PRINCETON FRONT ELEVATION "A"
 SCALE 1/8" = 1'-0"

Front & Rear Elevation

PLAN INDEX
 CL 3145

First Floor Plan

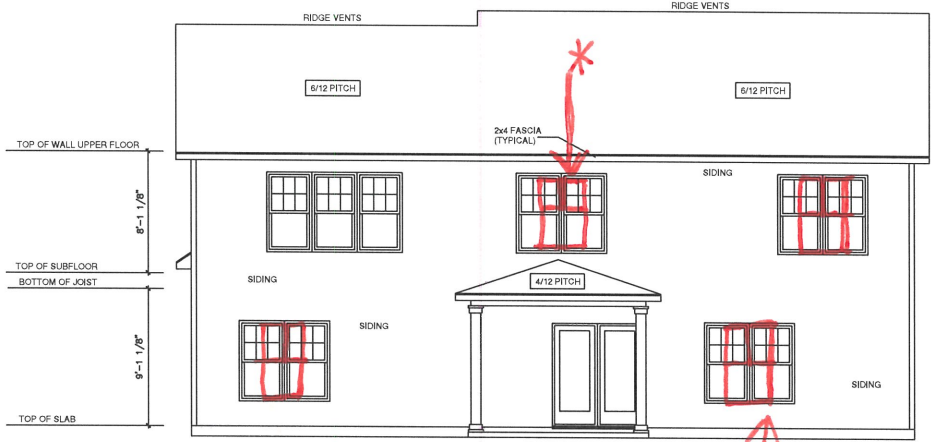
* Add window back in
 for Creekwood Farms

PRINCETON RIGHT ELEVATION "A"
SCALE 1/8" = 1'-0"

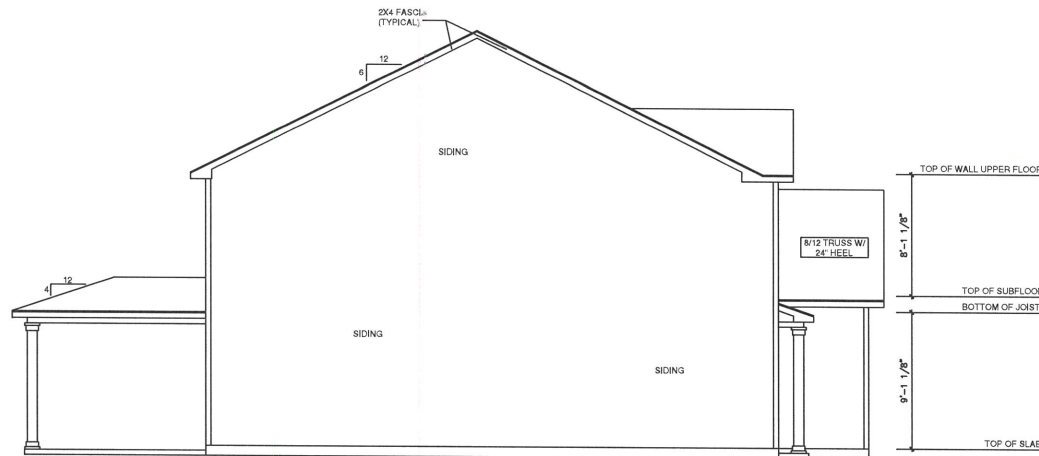
*add window back in for Creekwood Farms

SECOND FLOOR PLAN
SCALE: 1/8" = 1'-0"

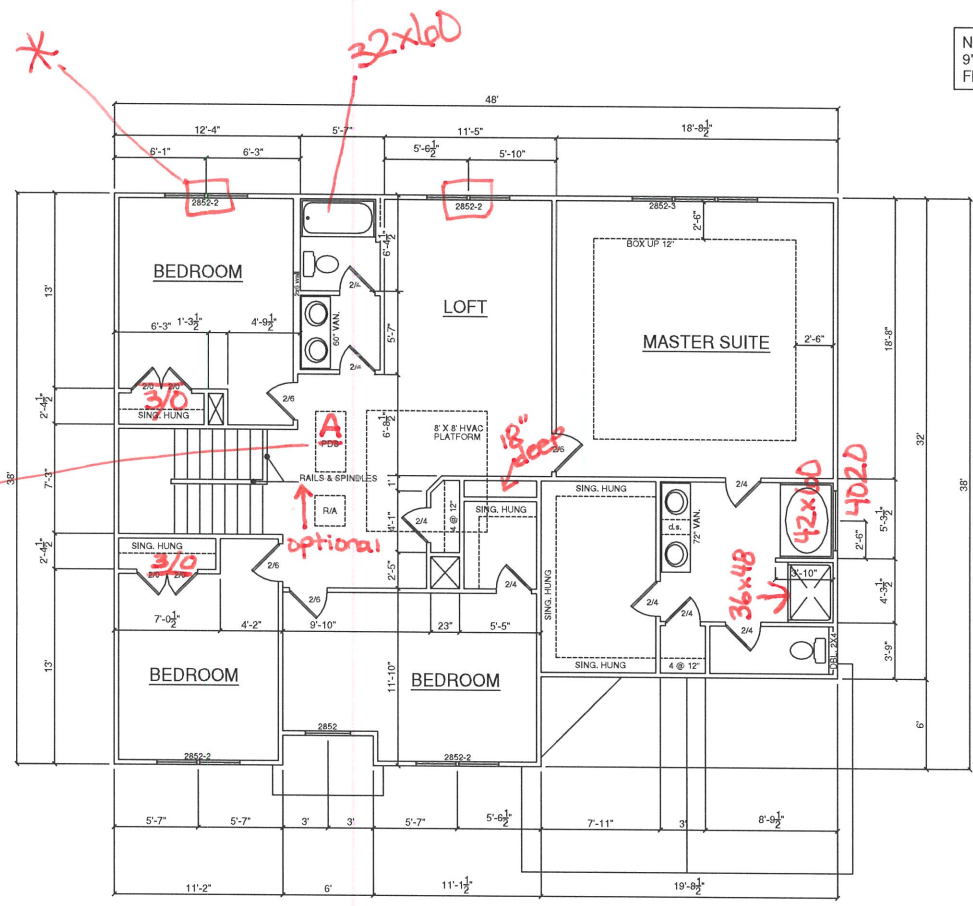
36x60 Shower only

*add back in for Creekwood Farms

move Access
down. Center
on platform
